Department of Energy
Office of Legacy Management

Subject: Revisions: Draft Long-Term Surveillance Plan for the Maybell West, Colorado,
UMTRCA Title II Site

TOE APRON SECTION

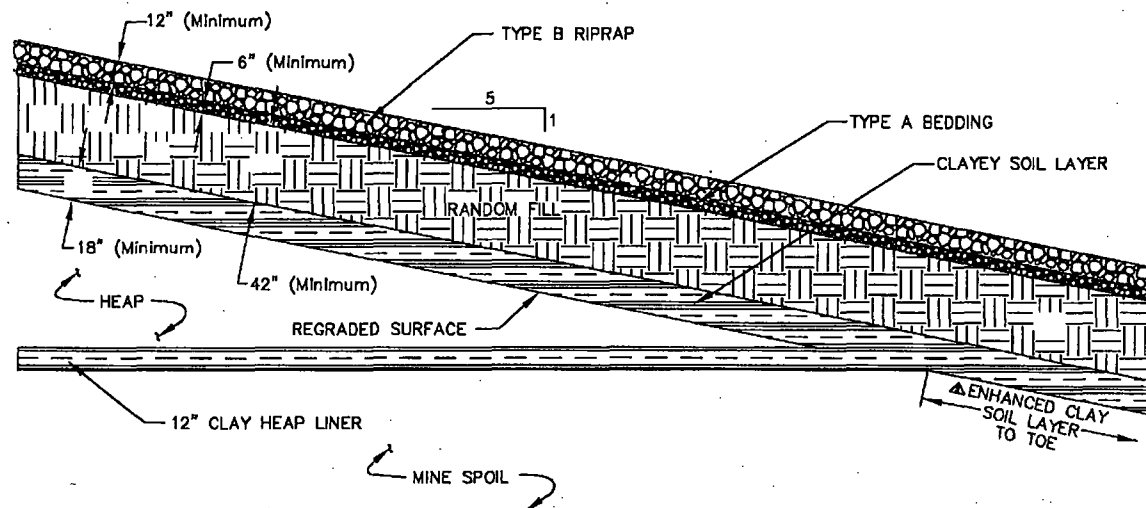
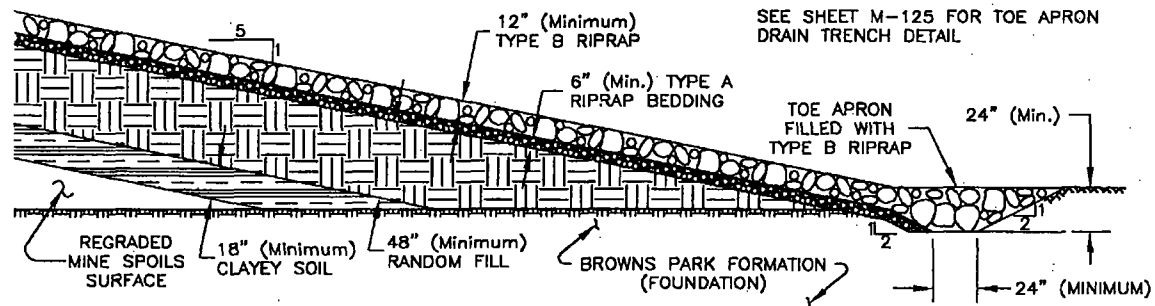
- Figure 2-6 (page 2-11) *Typical Cover Cross-Section, Maybell West, Colorado, Disposal Cell*: This figure was revised to include: the apron at the toe of the disposal cell.

U.S. DEPARTMENT OF ENERGY GRAND JUNCTION, COLORADO	Work Performed by S.M. Stoller Corporation Under DOE Contract No. DE-AC01-02GJ79491
DISPOSAL SITE MAP MAYBELL WEST, COLORADO	
DATE PREPARED: AUGUST 7, 2007	FILENAME: S0331600

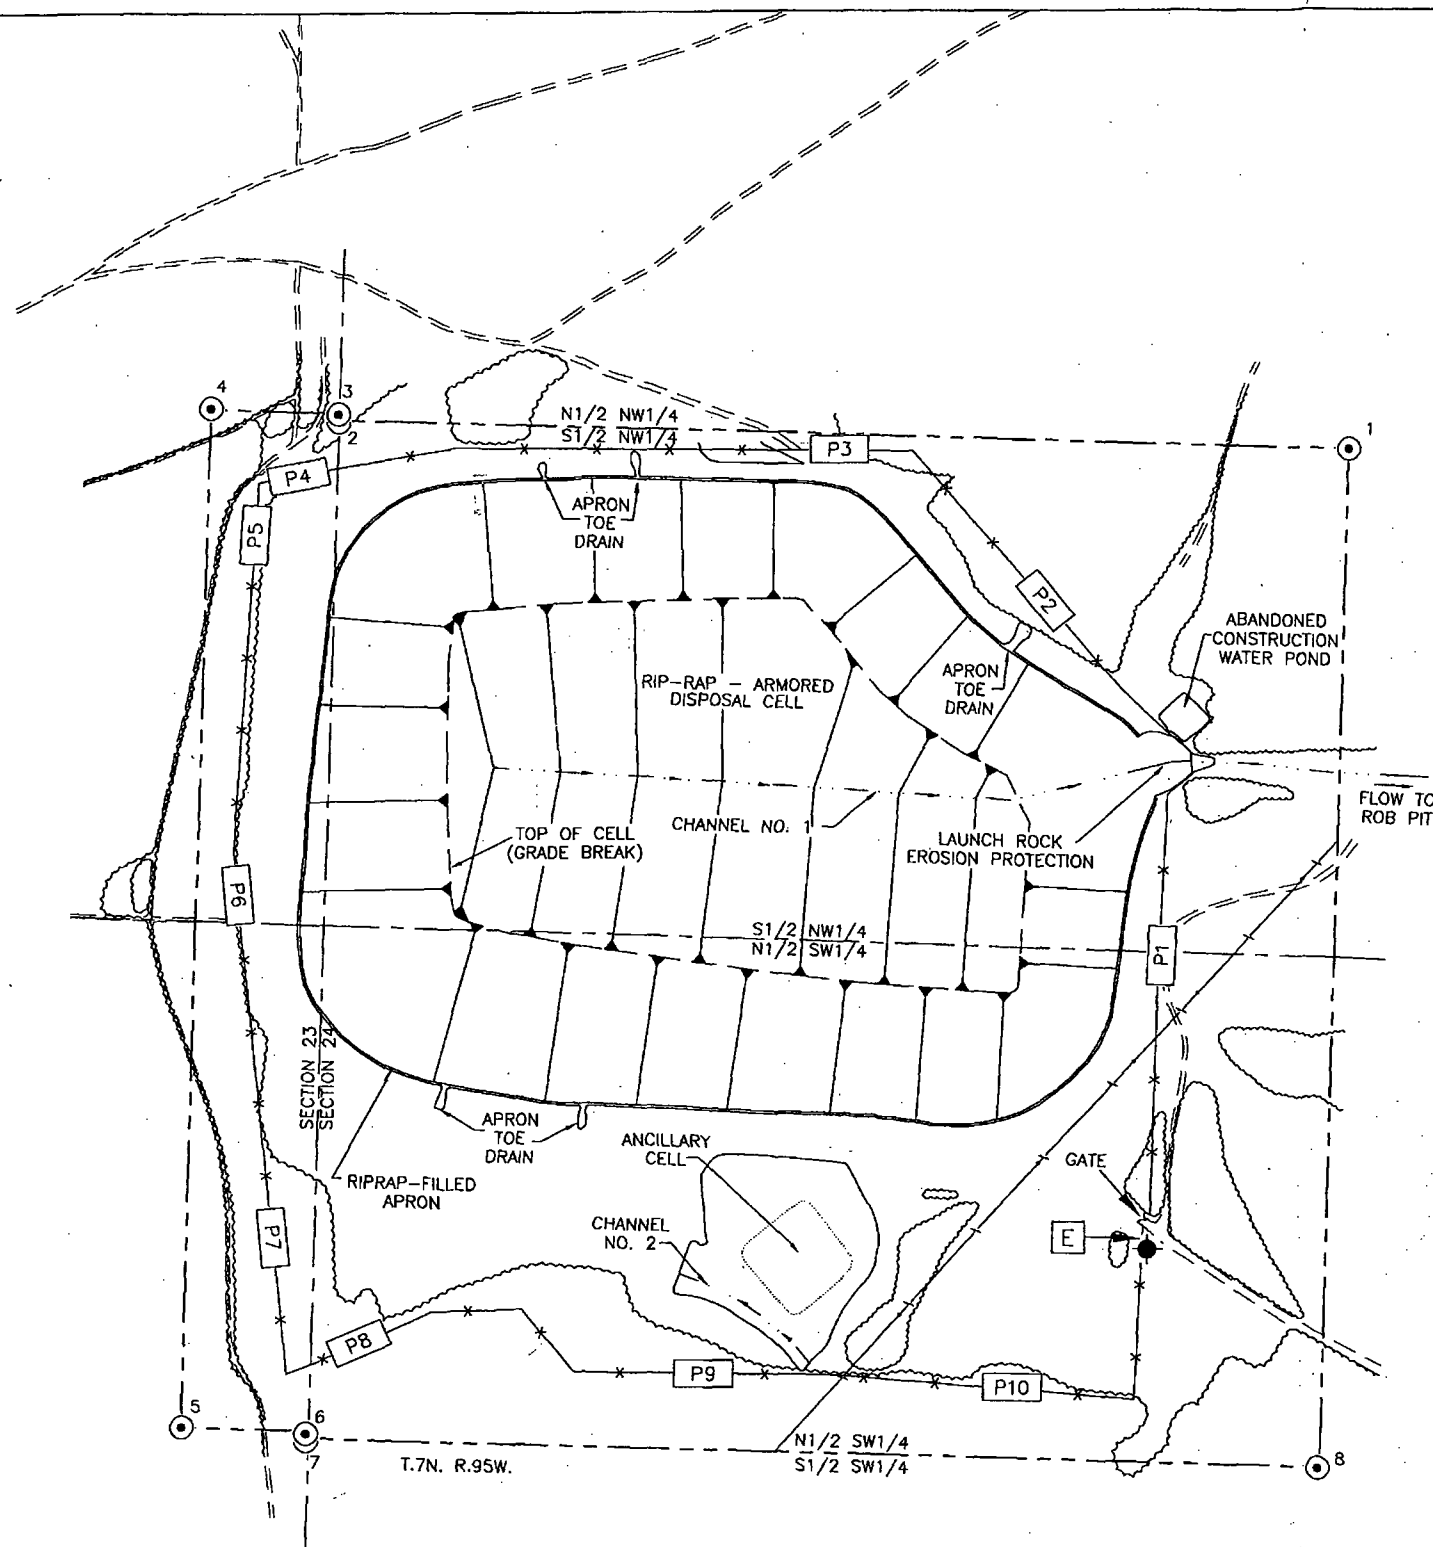
- Figure 2-2 (page 2-5) *Maybell West, Colorado, Disposal Site Map*: This figure was revised to include: the apron at the toe of the disposal cell; a grade break to distinguish the top of the cell from the side slopes; flow lines and flow direction in Channel No. 1 on the cell top; disposal cell slope direction lines; a correction to the scale; and perimeter warning signs locations.
